Access Compliance Report Public Rights-of-Way (Curb Ramps)

Intersection ID: 43839 Main Street: DELUCA_DR Cross Street: HAMEL_ST Location: SW

ADA ID: C3AC0C685539 Ramp Type: Perp Initial Pass/Fail: Pass Overall Compliance: No Severity Score: 7.5

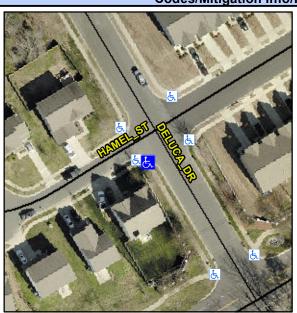
Not Found, R304.2.2-Perp, R304.3.2-Para, R305.1.4, R305.2, R304.5.4, R304.5.3

Compl	iance Description	Data	Comp	liance Description	Data
N/A	Ramp Length (in)	45.0	Yes	Ramp Slope (%)	7.1
Yes	Ramp Width (in)	48.0	Yes	Ramp XSlope (%)	0.9
N/A	Flare Type LT	Sloped	N/A	Flare Type RT	N/A
N/A	Flare Slope LT (%)	3.6	N/A	Flare Slope RT (%)	3.2
N/A	Flare Traversable LT?	No	N/A	Flare Traversable RT?	No
Yes	Landing Length (in)	56.5	Yes	DWS Provided?	Yes
Yes	Landing Width (in)	48.0	Yes	DWS Contrast?	Yes
No	Landing Slope (%)	2.2	Yes	DWS Length (in)	24.0
Yes	Landing X Slope (%)	0.5	No	DWS Full Width?	No
N/A	Landing Curb? (Y/N)	No	No	DWS Offset (in)	5.5
N/A	Shared Landing?	No			
Yes	Gutter Ponding?	No	No	Gutter Slope (%)	10.9
Yes	Gutter Lip Ht (in)	0.0	No	Gutter X Slope (%)	3.1
N/A	Painted X Walk1?	No	N/A	Painted X Walk2?	N/A
	X Walk 1 Direction	To E		X Walk 2 Direction	N/A
N/A	X Walk 1 Width (in)	N/A	N/A	X Walk 2 Width (in)	N/A
	X Walk 1 Slope (%)	1.7		X Walk 2 Slope (%)	N/A
	X Walk 1 X Slope (%)	2.7		X Walk 2 X Slope (%)	N/A

Remove & Replace Entire Ramp.
Remove & Replace Gutter.
